# UNITED STATES PATENT AND TRADEMARK OFFICE

APPLICATION NO.	FILING DATE	FIRST NAMED INVENTOR	ATTORNEY DOCKET NO.	CONFIRMATION NO.
10/604,112	06/26/2003	Shahid Butt	FIS920030087	1111
30449	7590	08/01/2005	EXAMINER	
SCHMEISER, OLSEN + WATTS			LEE, EUGENE	
3 LEAR JET LANE			ART UNIT	
SUITE 201			PAPER NUMBER	
LATHAM, NY 12110			2815

**Office Action Summary**

## DETAILED ACTION

Fig.2

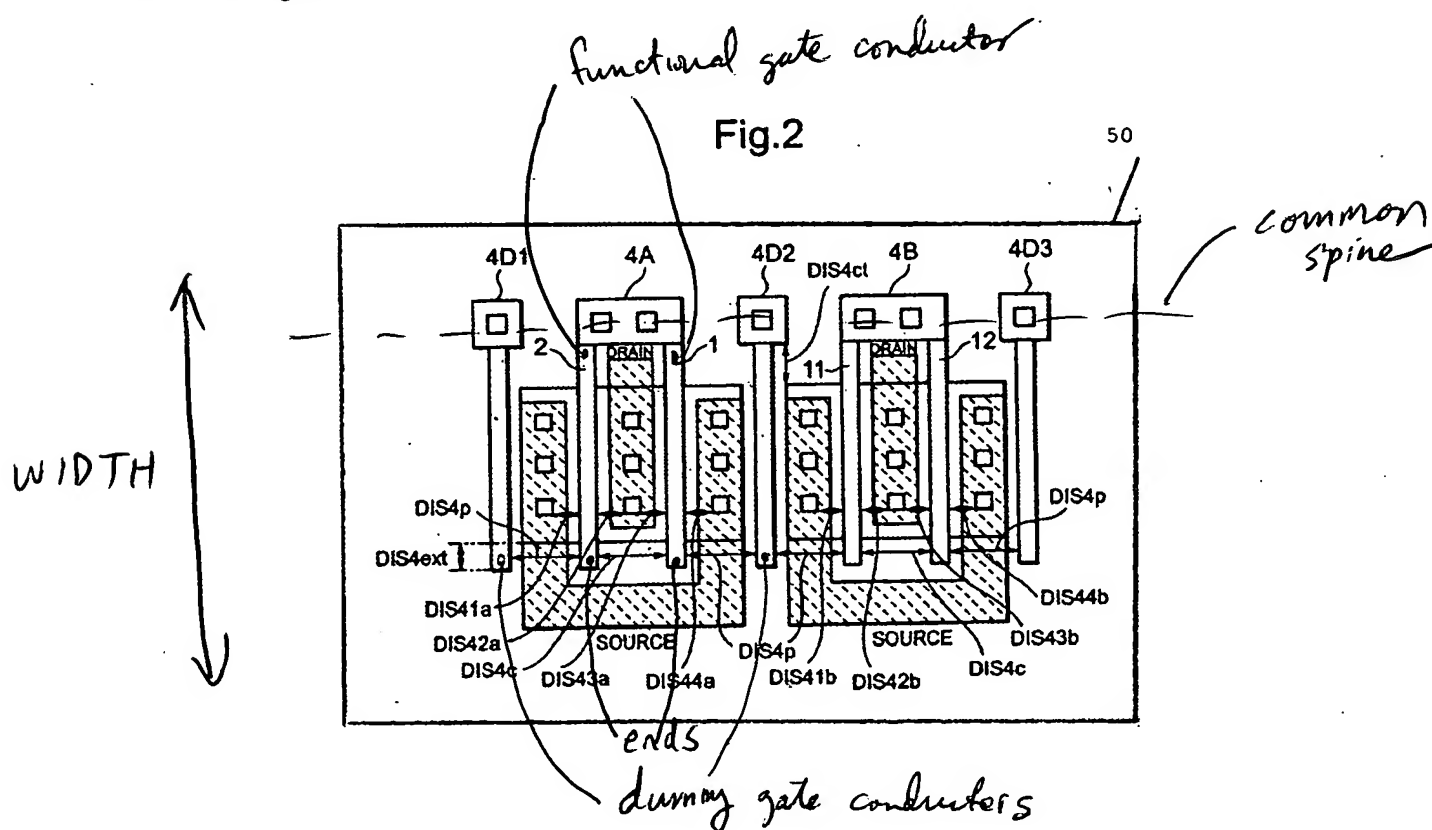
5. Insofar as definite, claims 1, 4 thru 12, and 15 thru 22 are rejected under 35 U.S.C. 103(a) as being unpatentable over Iwasaki 6,833,595 B1 in view of Uehara et al. 5,946,563. Iwasaki discloses (see, for example, Fig. 2) a semiconductor device (electronic device) comprising a semiconductor substrate, transistor 4A, gates (functional gate conductors) 1, 2, common spine, dummy gates (dummy gate conductors) 4D1, 4D2, and element isolation region (insulating layer) 50. The gates extend in a widthwise direction from a common spine, the common spine

extending in a direction perpendicular to said widthwise direction. The gates are positioned substantially parallel to each other in said widthwise direction and periodically spaced apart a fixed distance in said direction substantially perpendicular to said widthwise direction. The dummy gates are positioned substantially parallel to each other in a widthwise direction and periodically spaced apart a fixed distance in a direction substantially perpendicular to said widthwise direction. The dummy gates are not positioned between gates 1, 2 and adjacent to ends of said gates.

Regarding claims 4, and 15, see, for example, Fig. 2 wherein Iwasaki discloses the dummy gates 4D1, 4D2, and gates 1,2 having the same gate widths.

Regarding claims 5, 6, 16, and 17, see, for example, Fig. 2 wherein Iwasaki discloses dummy gate (additional dummy gate conductors) 4D3.

Regarding claims 9, 10, 20, and 21, see, for example, Fig. 2 wherein Iwasaki discloses source/drains SOURCE /DRAIN.
